Technical Note

Project: Earl Shilton, Leicestershire

Subject: Response to Leicestershire County Council's Comments

Client:	Vistry		
Project No:	09924	Version:	A
Document Ref:	09924-TN-02	Author:	Lewis Griffiths
Date:	25/06/2026	Approved:	Richard Ellam

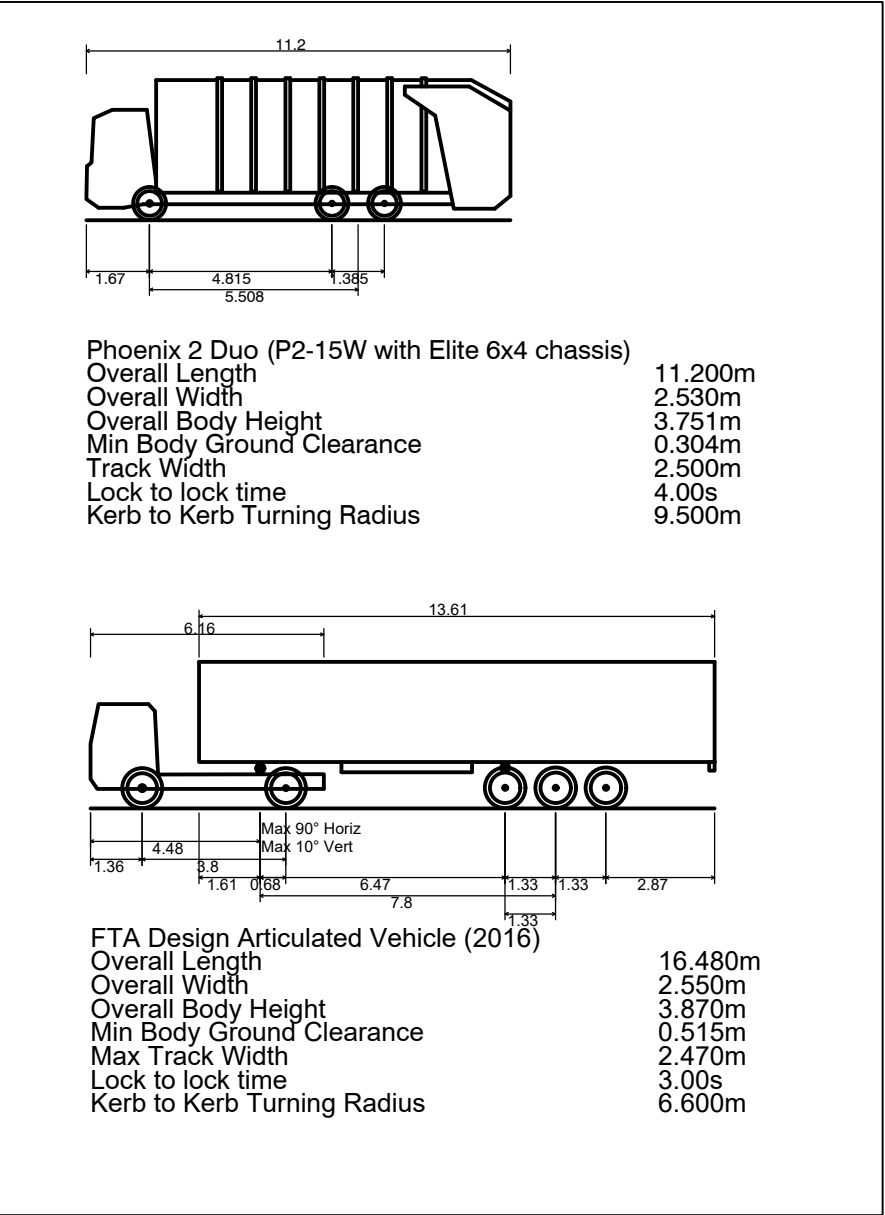
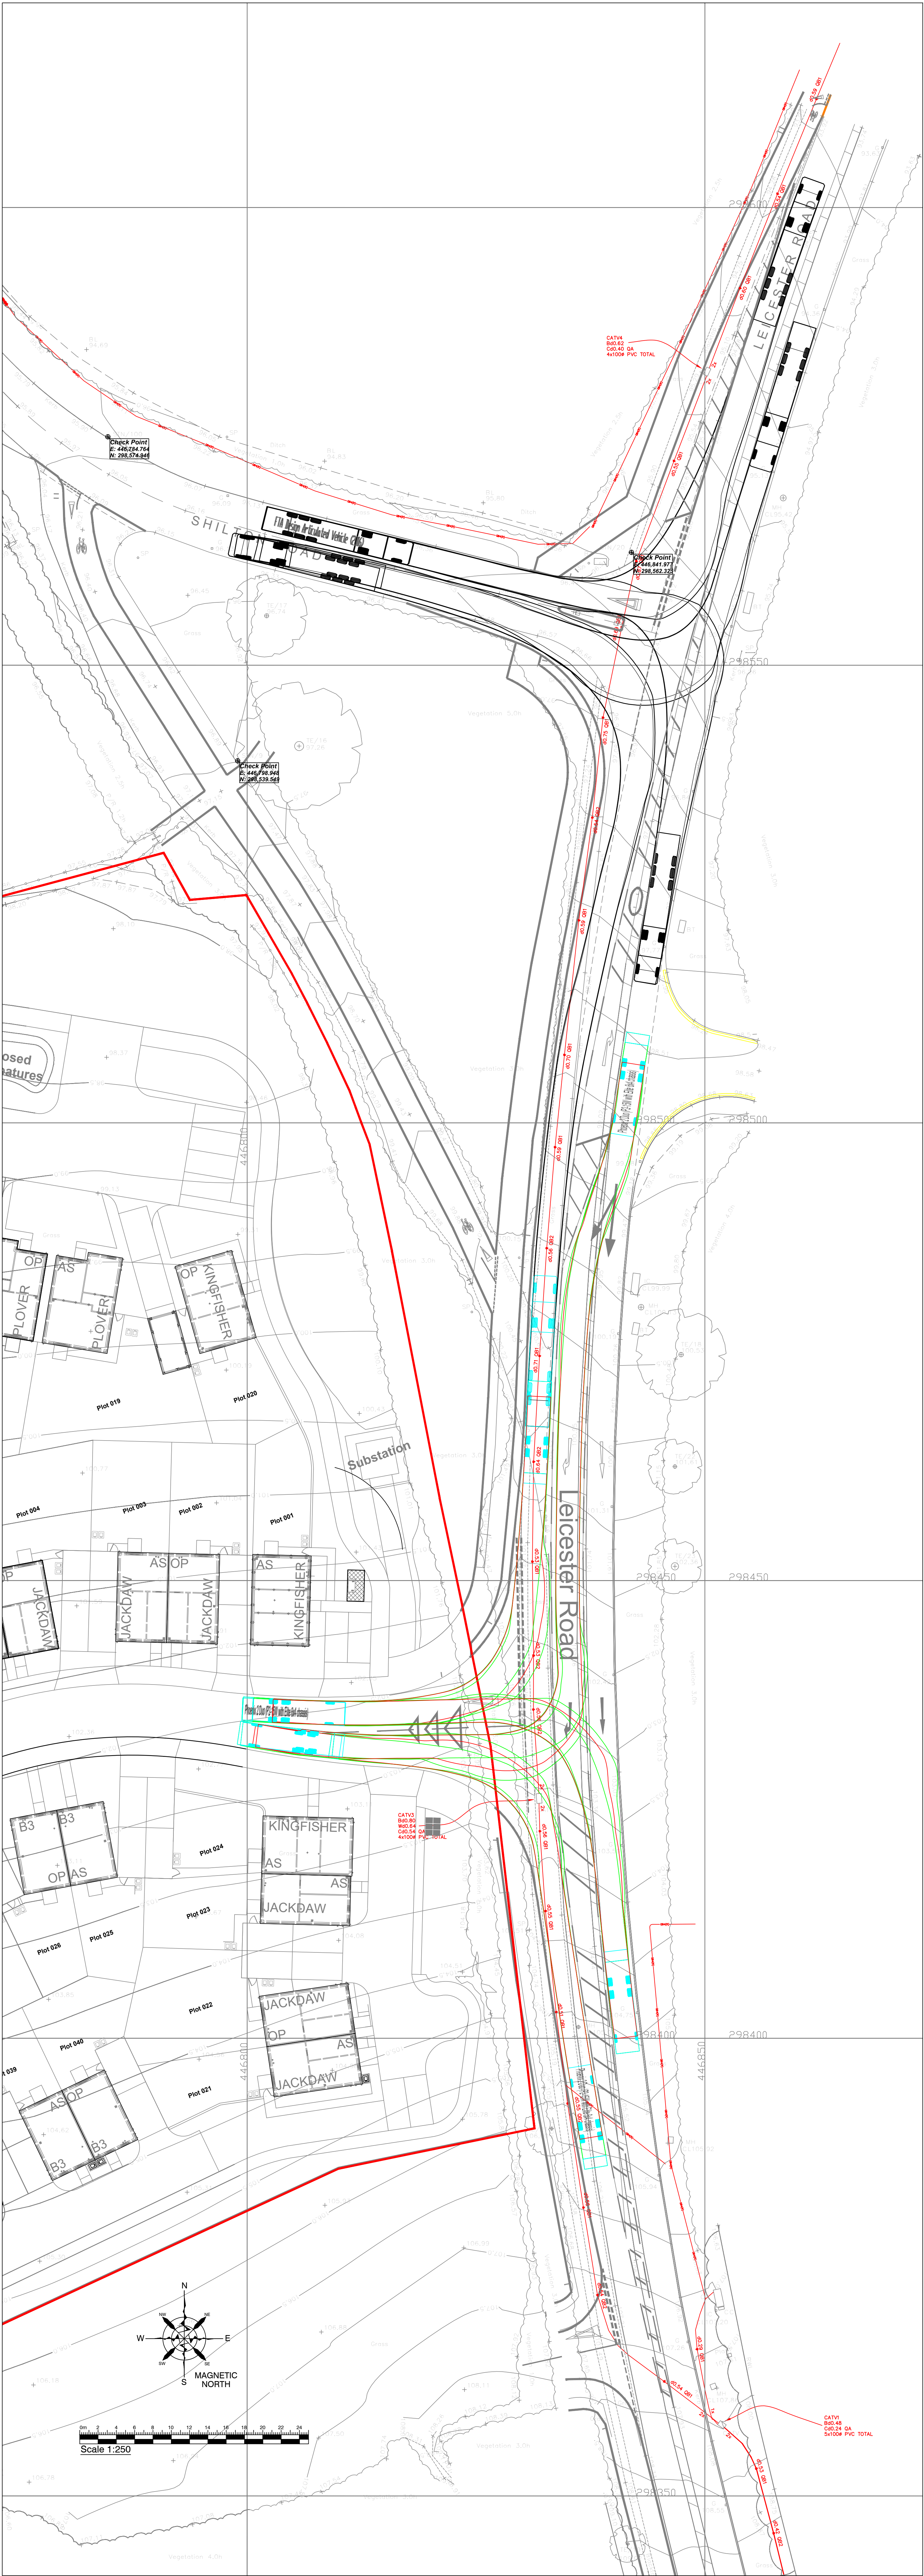
“The 50m length visibility splays shown for the ghost island right turn lane are not in accordance with the Design Manual for Roads and Bridges (DMRB) for a design speed of 30mph. For a design speed of 50kph the desirable minimum Stopping Sight Distance as per DMRB CD109 Table 2.10 is 70m.

However, for 85th percentile vehicle speeds of up to 35mph, a 54m length splay is required as per Table 6 of the Leicestershire Highway Design Guide (LHDG - <https://www.leicestershirehighwaydesignguide.uk/>). This would be more appropriate for the northern access, and it is suggested the splay length should also be used for the Hill Top Farm access, which currently shows splays of 47m (30mph in LHDG Table 6)”

3.1.8 Upon review of the visibility assessment, we accept the recommended visibility splay requirement in accordance with Table 6 of the Leicestershire Highway Design Guide and have increased the length of the visibility splays to 54m as required for 85th percentile vehicle speeds of up to 35 mph.

Proposed Access Arrangement

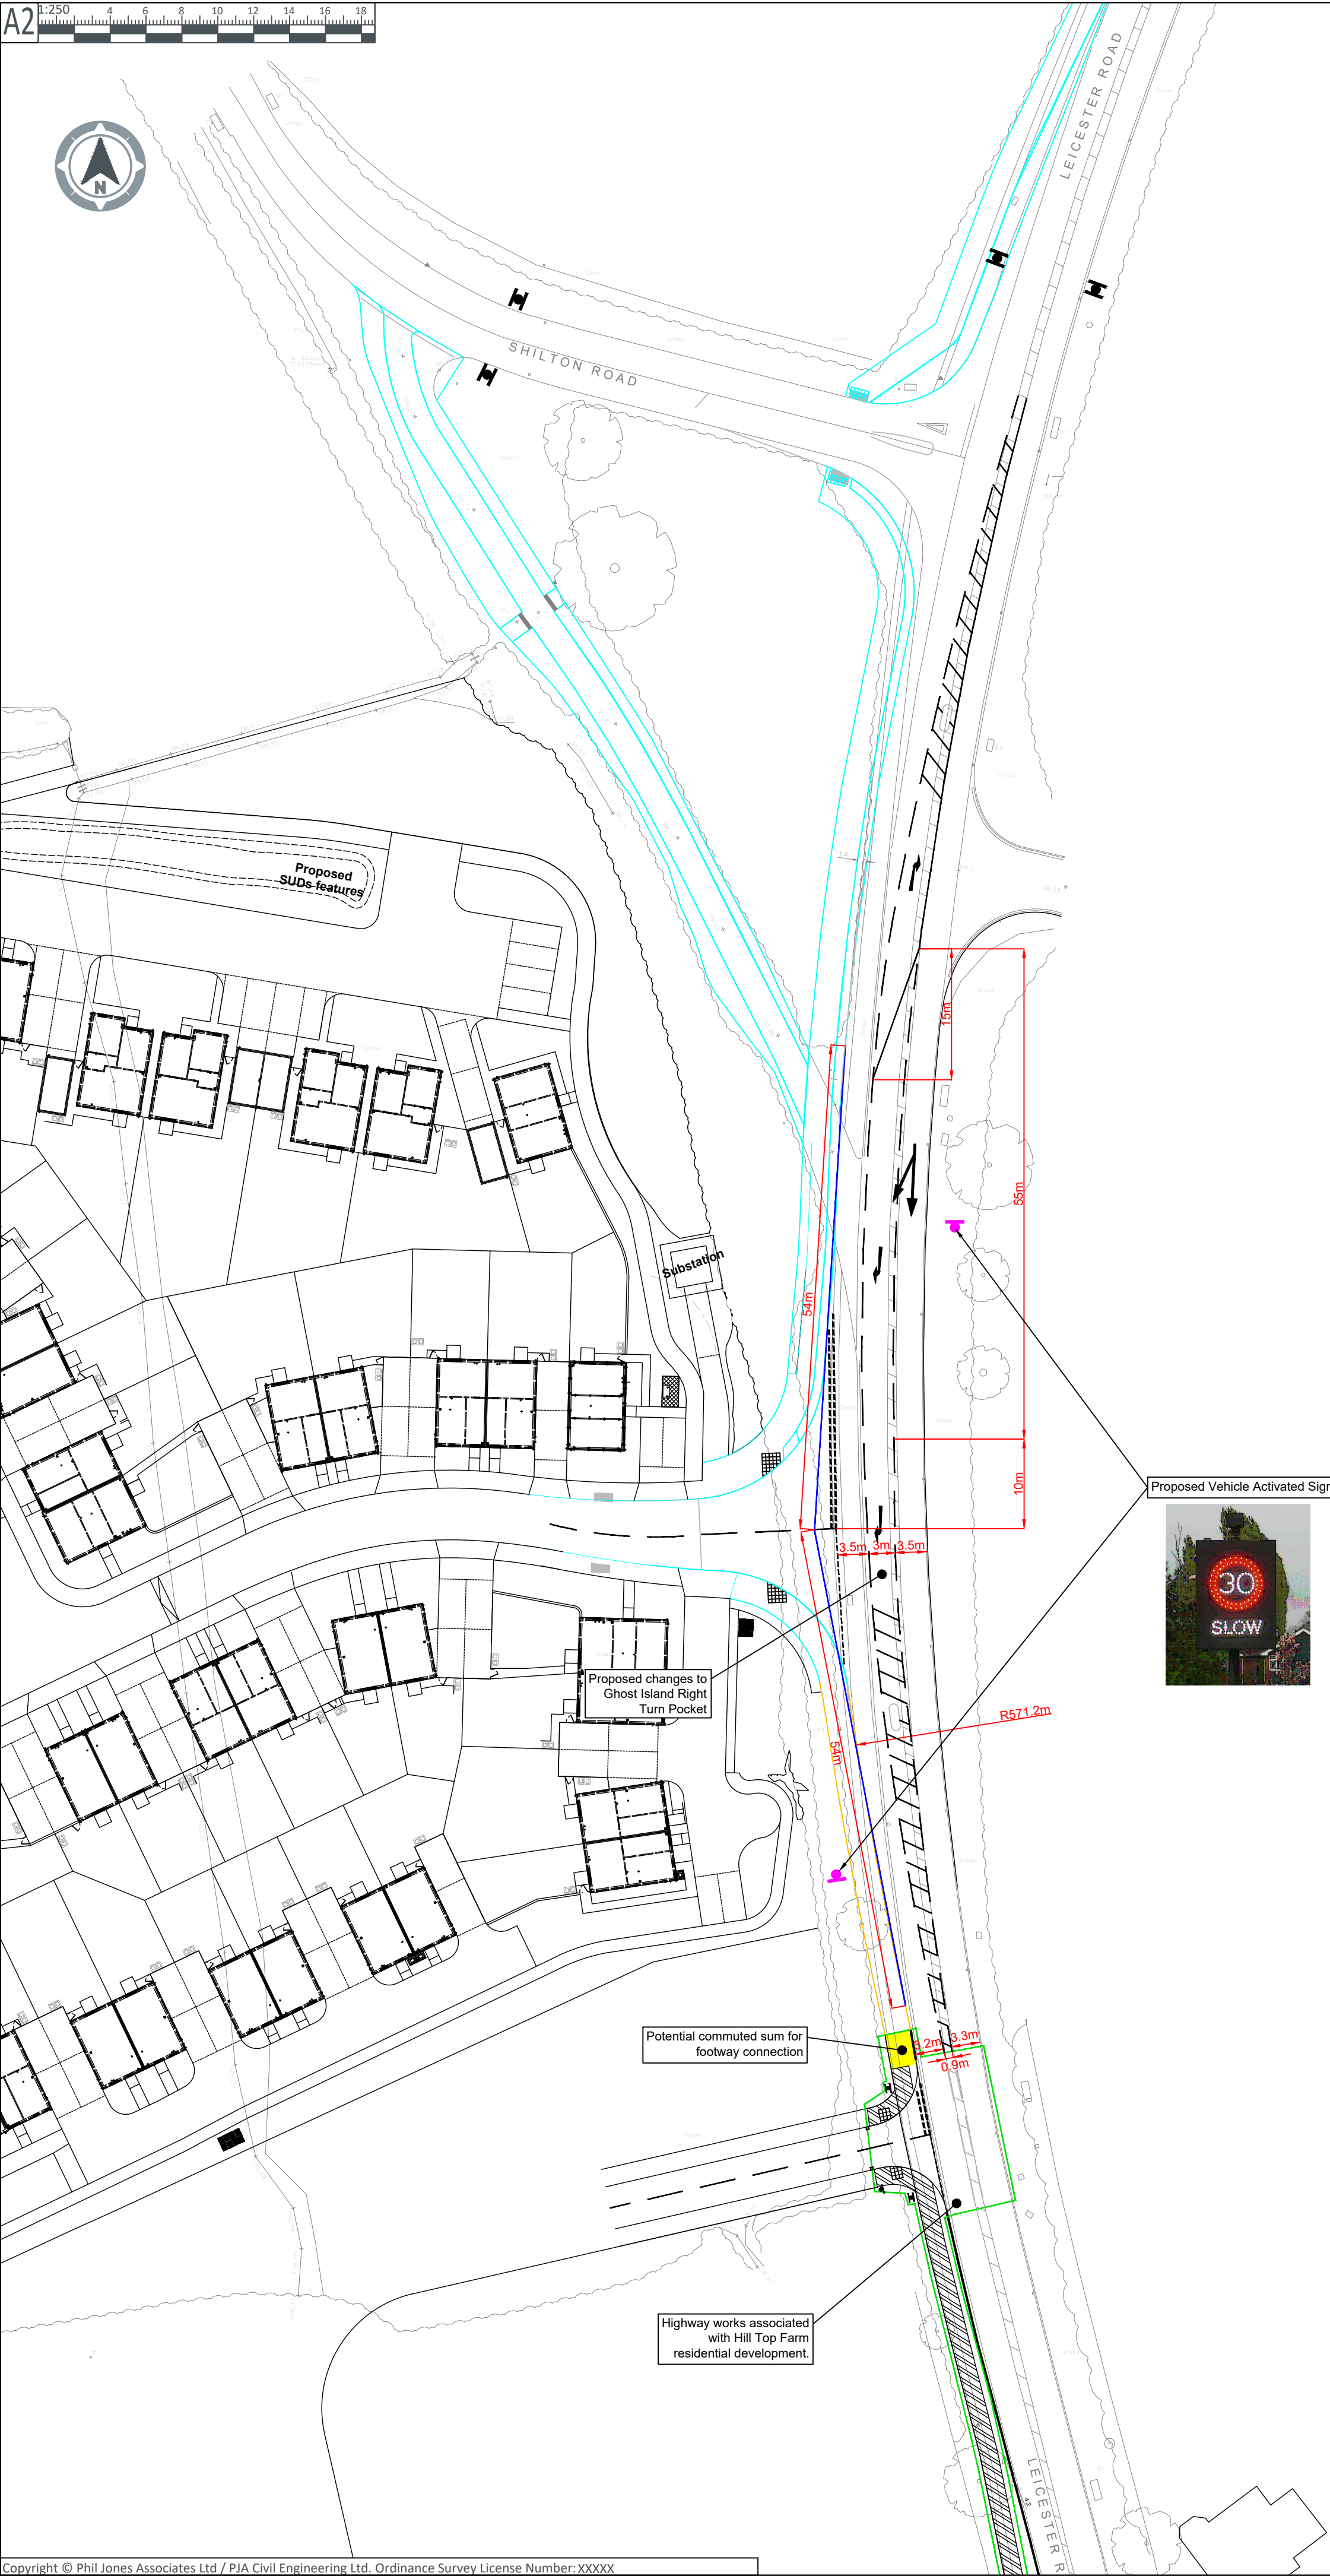
A double right turn lane arrangement is provided adjacent to the proposed residential access and an unnamed road on the east side of Leicester Road. The Auditors are concerned that the wide carriageway at this point could lead to road users undertaking inappropriate overtaking manoeuvres across the centre line hatching and the right turn lanes.

It is recommended that full height kerbed traffic splitter islands surmounted by appropriate illuminated or reflective bollards are provided within the centre line hatching on both the northbound and southbound approaches to the right turn lanes identified.

The Audit Team note that the proposed junction layout incorporates back-to-back right-turn lanes with no physical separation between opposing traffic streams.

It is recommended that a physical traffic splitter island, or other suitable form of positive segregation, is provided between the opposing right-turn lanes, to deter incorrect use of the right-turn facilities.

The Audit Team note that the northbound only section of Shilton Road appears to be stopped up as part of the proposals. However, the drawing provided for Audit does not clearly indicate the form of closure that is to be provided at the point where vehicular access is terminated.

It is recommended that the stopping-up arrangement is to be clearly defined and designed to be conspicuous to approaching traffic. Appropriate measures may include a physical closure feature, signing, road markings, and high-visibility materials to ensure road users are provided with clear and timely indication that the route is no longer available to through traffic.

The Audit Team are not aware of any swept path assessment having been undertaken to demonstrate that the junction can safely accommodate the anticipated increase in turning movements, particularly by larger vehicles. If the junction geometry is insufficient, larger vehicles may overrun kerbs, enter opposing traffic lanes, or conflict with pedestrians when undertaking the turn.

It is recommended that swept path analysis be undertaken using appropriate design vehicles to demonstrate that vehicles displaced by the closure of the northern section of Shilton Road can safely negotiate the left-turn movement from Leicester Road into Shilton Road. Where necessary, the junction geometry should be amended to safely accommodate these turning movements.

RSA problem	RSA recommendation	Design Organisation response	Overseeing Organisation response	Agreed RSA Action
3.1	It is recommended that full height kerbed traffic splitter islands surmounted by appropriate illuminated or reflective bollards are provided within the centre line hatching on both the northbound and southbound approaches to the right turn lanes identified	Agreed, there is sufficient space to accommodate these within the hatched areas.

3.2	It is recommended that a physical traffic splitter island, or other suitable form of positive segregation, is provided between the opposing right-turn lanes, to deter incorrect use of the right-turn facilities	Consider the white lining proposed sufficient to provide positive segregation

3.3	It is recommended that the stopping-up arrangement is to be clearly defined and designed to be conspicuous to approaching traffic. Appropriate measures may include a physical closure feature, signing, road markings, and high-visibility materials to ensure road users are provided with clear and timely indication that the route is no longer available to through traffic	Agreed exact measures to be considered at detailed design stage.

3.4	It is recommended that swept path analysis be undertaken using	Noted, this has been carried out previously.
